Commission of Architectural Review SUBMISSION APPLICATION

Renovation of 119 E. Leigh Street

HISTORIC PRESERVATION CERTIFICATION APPLICATION
 PART 2 - DESCRIPTION OF REHABILITATION

CONDITIONS SHEET ~ Part 2
Historic Preservation Certification Application

REFLECTED CEILING
 PLANS
A.601

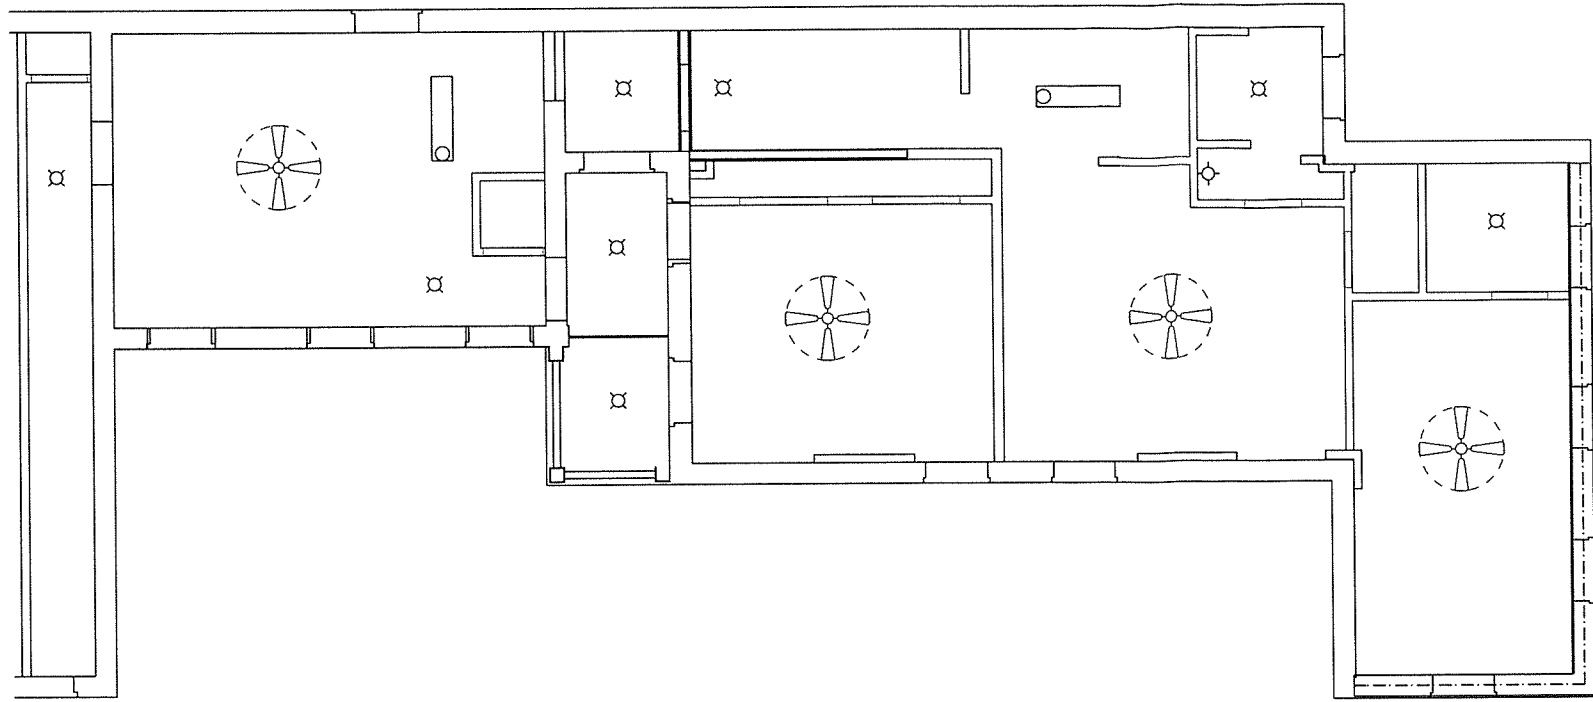
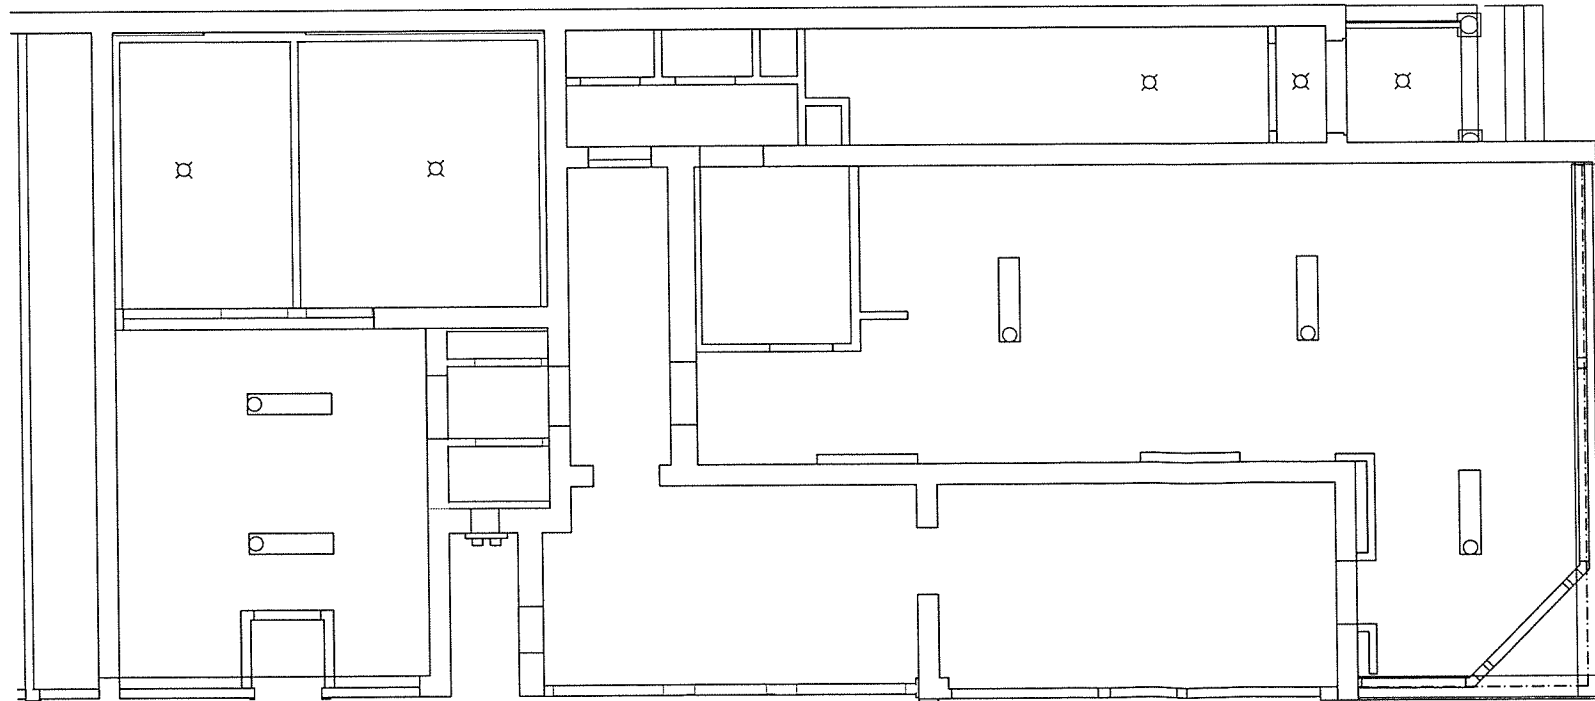
Reflected Ceiling Plan ~ please submit a reflected ceiling plan noting the locations of proposed soffits.
